Andrew Thomas  
Planning Board Members  
City of Alameda, CA

I would like to comment on the development planned at Oak Street and Clement Street known as Boatworks.

Image A Types of Units

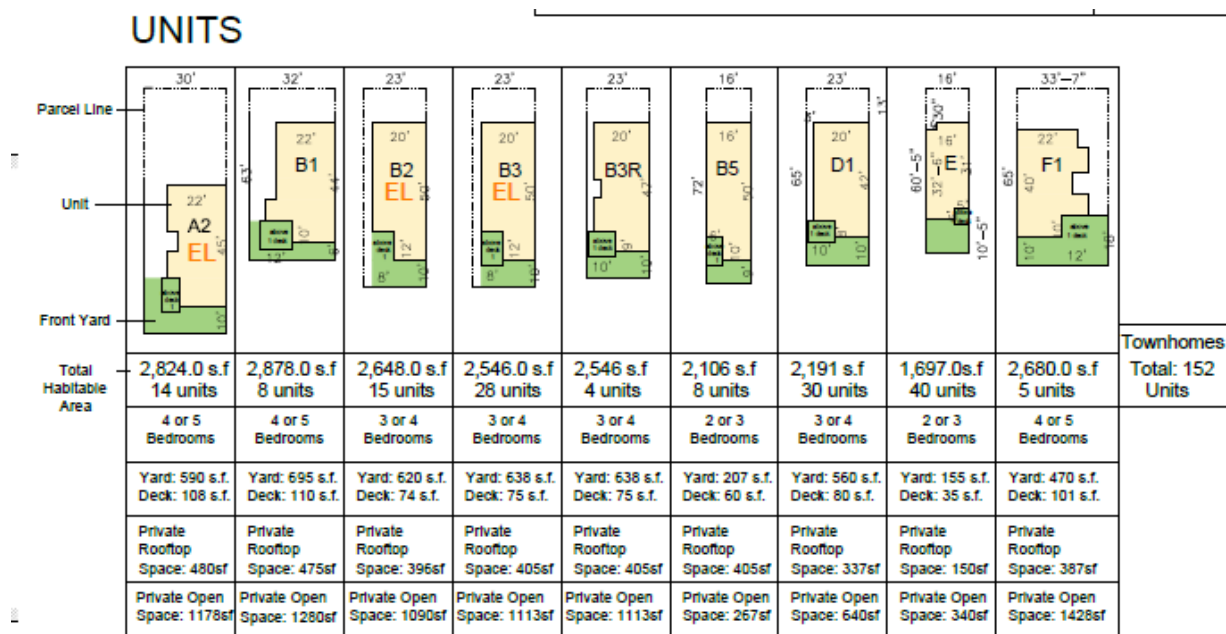
- e. One hundred three units are designed with the capability of 4 or more bedrooms. The B1 floor plan was missing from the package I downloaded so I assumed it was similar to A2 . Of the units with more than 4 bedrooms, only A2, F1 and possibly B1 have 2 car garages. F1 has room for a regular car and a smaller car. So only 19 or 27 units, if B1 is included, have confirmed 2 car garages. Eighty one units have two car garages but are pre-fabricated for converting one of the spaces into another bedroom.
- f. The following Image B is the parking space chart from page ps/DP-7 of the Boatworks package.

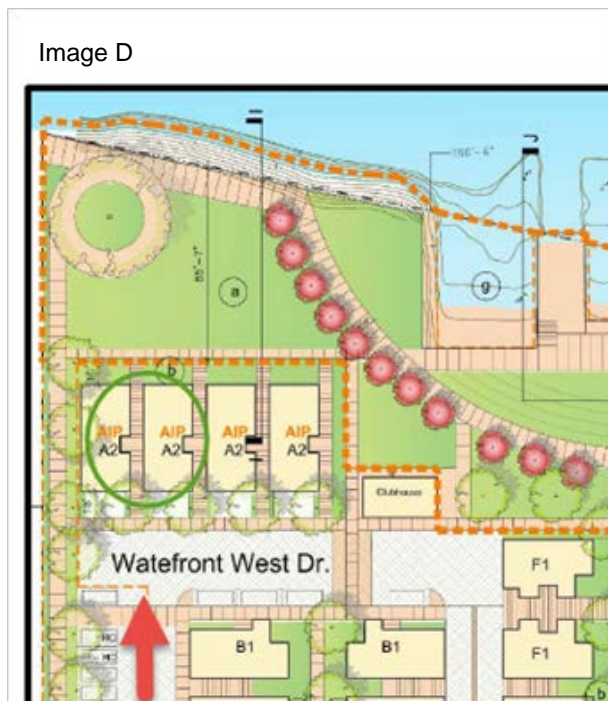
- a. The apartment building at the corner of Oak Street and Clement Street should be moved. It is too tall and ill designed for a major city corridor. Moving the building to the center of the development would make the building appear to be shorter and improve the view of the Oakland hills from the intersection. This intersection is part of the Alameda Gateway and should be designed as such.
- b. Dividing the building into 2 separate buildings would reduce the bulkiness of the building and improve the overall look of the development.
